NUCLEAR REGULATORY COMMISSION

Title: Advisory Committee on Reactor Safeguards
571st Meeting: OPEN SESSION

Date: Thursday, April 8, 2010

Many of you have noticed certification of new reactor designs occupies an increasing fraction of our subcommittee meeting time, and many of those are of the passive persuasion, but now they have a plant that they were going to look at that is active and, more importantly, that are actually being built around the world. So they're really interesting plans. We're going to discuss a little bit about the EPR.

Main Safety Systems

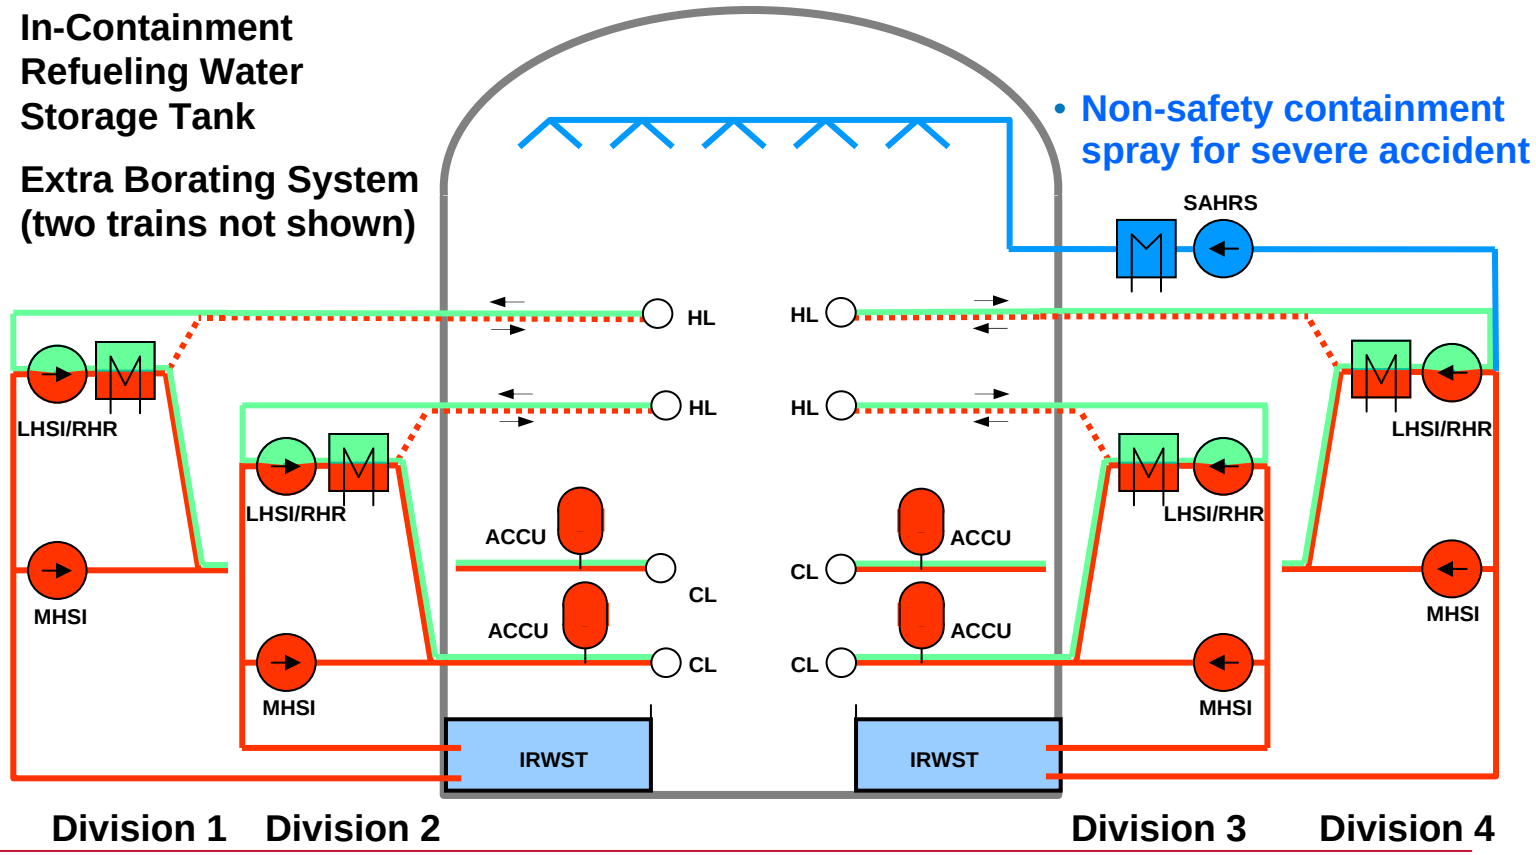
VICE CHAIRMAN ARMIJO: The figure shows some dashed red lines to the hot legs.

VICE CHAIRMAN ARMIJO: I have one other question with that. When you say extra borating system, that implies to me that there's some non-extra, that is, regular borating system.

MR. STACK: The dashed, what you see in here from the LHSI, they're really showing two things. Sorry for the busy figure. The dashed line is really showing an alternate alignment for hot leg injection. The green line is really showing the normal RHR line-up where you take it from the hot leg back into the pump and back to the cold leg..

Main Safety Systems Secondary Side

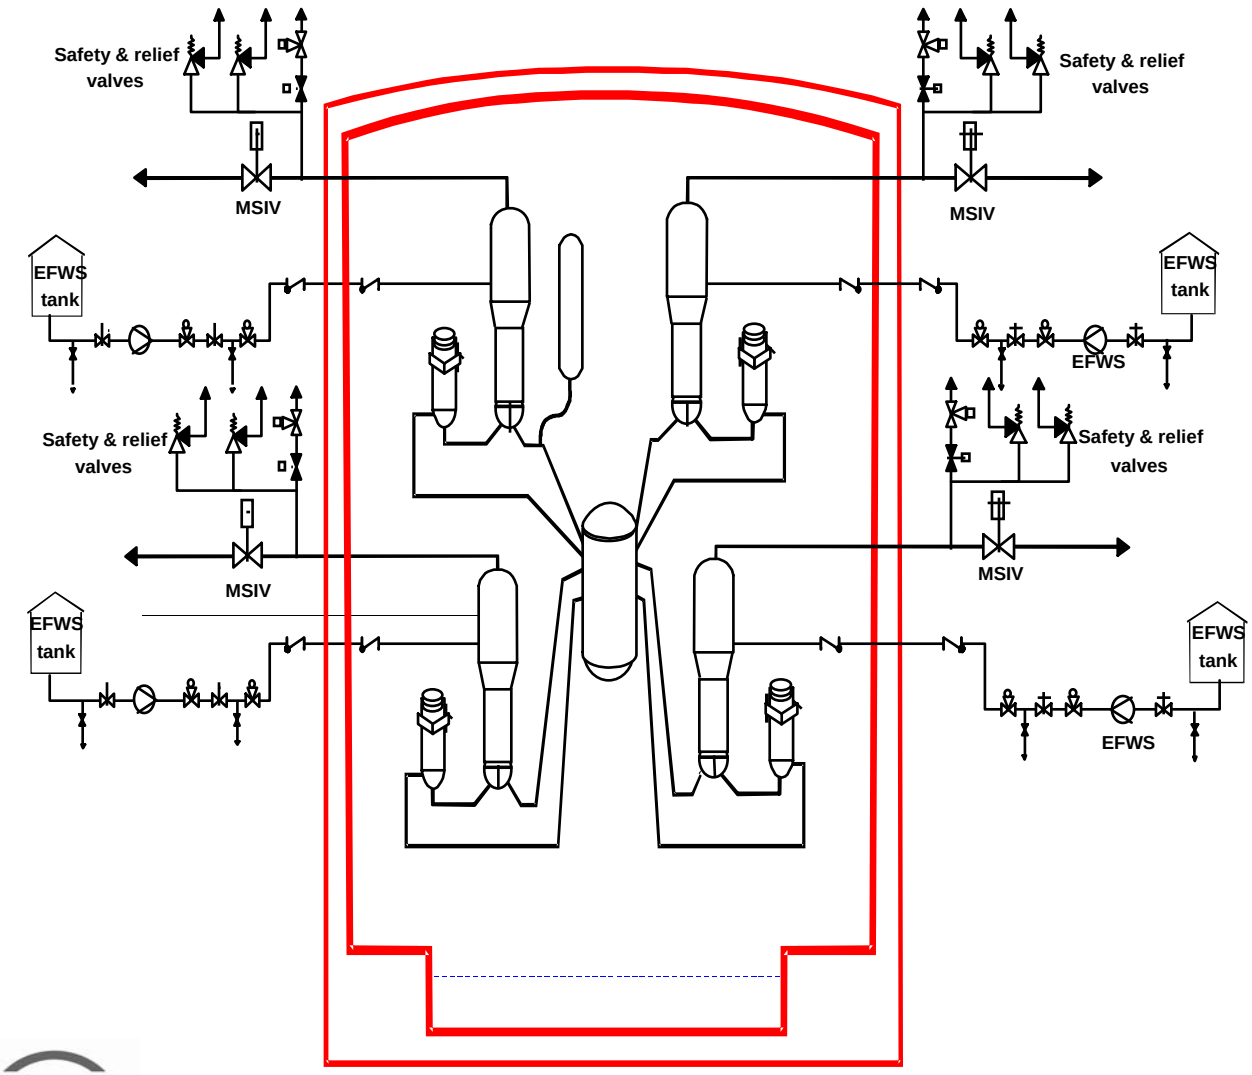
MEMBER RAY: One last question. I'm sorry. At the moment. Be patient. You would think that you would not use the affected steam generator for your depressurization, I guess.

MEMBER BLEY: What the questions are really aimed at is during that initial time when you are dumping, but you're not dumping to atmosphere anymore. This doesn't dump to atmosphere, right?

MR. STACK: That's going to happen with those generators, in the end what we will do is transfer inventory from that generator to one or the other intact generators to get the plant all the way down and cooled down. At the end of the day we need to ultimately reduce inventory in all four generators
